# NES MANUFACTURING

Reference: Nuclear Energy Services Manufacturing  
Docket No. 99901018/85-01

## APPENDIX A

### USNRC Request for Additional Information on Notice of Violation

EXHIBIT B.1.1

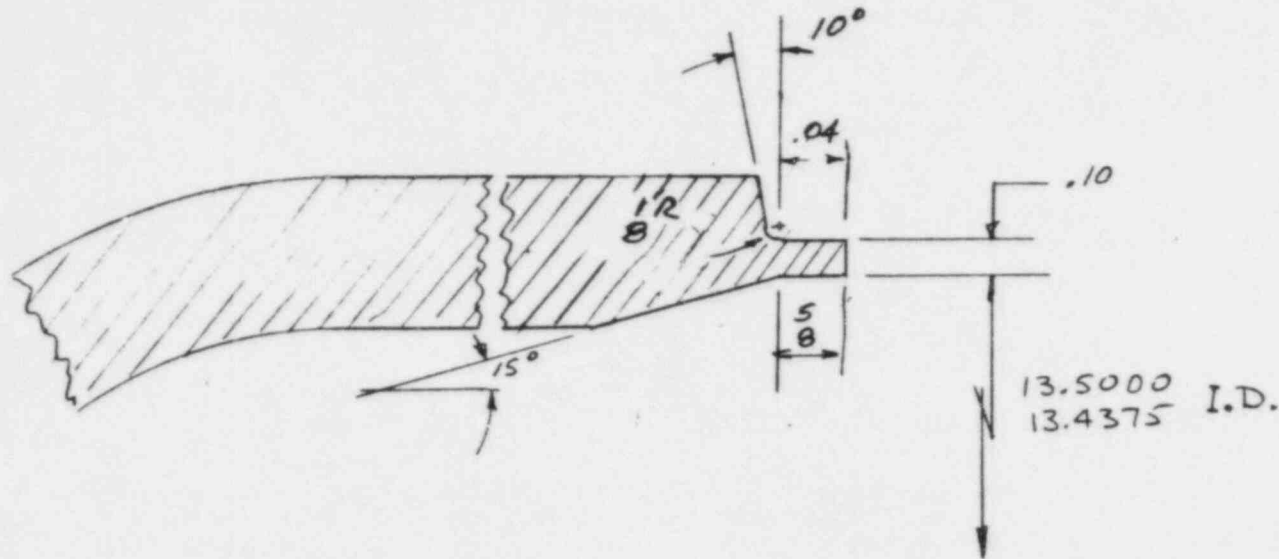
The NES response stated that receiving inspection was performed consistently for the items furnished. This is contrary to the NRC inspector's findings (i.e., dimensional checks to assure correct size were not performed on the neutron poison shrouds, upper closure heads, bulkheads, filter bundles, recombined catalyst and DEOXO-D catalyst). Provide copies of the documentation to verify that Bechtel supplied documents (e.g., data packages) were reviewed for adequacy by NES.

NES Manufacturing did not mean to imply with respect to the Bechtel-supplied items that we were in full compliance with our procedures or that extensive receiving inspection had been performed. The "Preventive Action" portion of our original response committed to necessary corrective action. As noted in our response, receiving inspection was performed as follows for the items noted:

Similarly, the lower closure heads were inspected in the vendor's shop by our customer and were subject to verification of documentation availability at NES Manufacturing. Dimensional checks of diameter and head depth were performed by NES Manufacturing because the weld preparation was to be remachined from a single vee geometry to a "J" bevel to accommodate automatic GTAW. Dimensional verification was necessary to assure adequate overall length of the head. The traveler attached as Exhibit B.1.1 contains documentation of the machining measurements and a signoff for Operation No. 10 for compliance with Bechtel Purchase Order No. TC-016160-3.
